**Westcoast Energy Inc., doing business as Spectra Energy Transmission (Westcoast)
Wyndwood Pipeline Expansion Project (Project)
Application under Section 58 of the National Energy Board Act,
dated 21 October 2016 (Application)
File No.: OF-Fac-Gas-W102-2016-12 01
Order: GH-001-2017**

Response to NOVA Gas Transmission Ltd. Information Request No. 1

Transmission North System

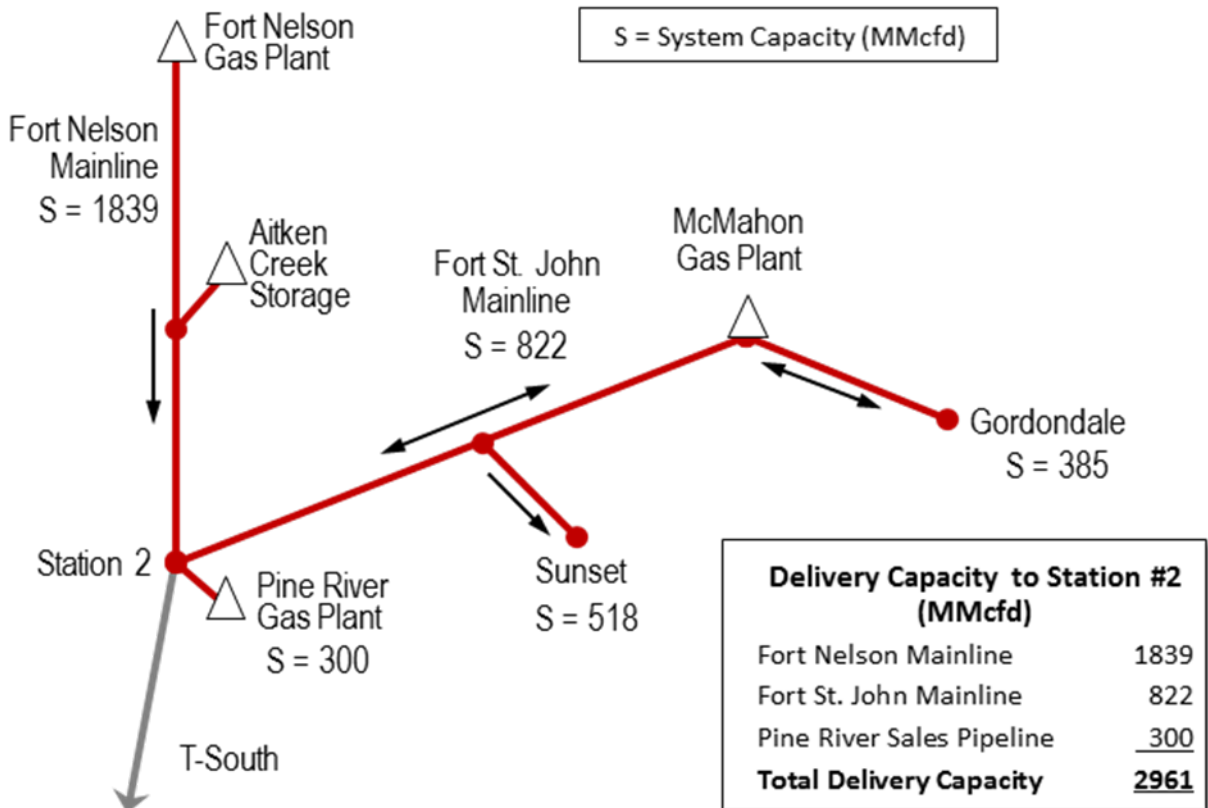
- e) Please provide a schematic of a capacity simulation of the T-North system to deliver gas to Compressor Station No. 2. Detail the T-North delivery and receipt contract distribution and unknown flow assumptions when determining this capacity.

- f) Please provide a schematic of a capacity simulation of the T-North system to deliver gas at Compressor Station No. 16. Detail the T-North delivery and receipt contract distribution and unknown flow assumptions when determining this capacity.

The contract capacity schematic of the T-North system for deliveries to Compressor Station No. 2 and to Compressor Station No. 16 (Sunset) is shown below (as of April 1, 2017 when the Jackfish expansion project is expected to be in service). As indicated in c) i) and ii) above, the firm contract receipt and delivery points are included in the hydraulic modeling. As indicated in c) vi) above, Westcoast does not include “unknown flow points” in its analysis.
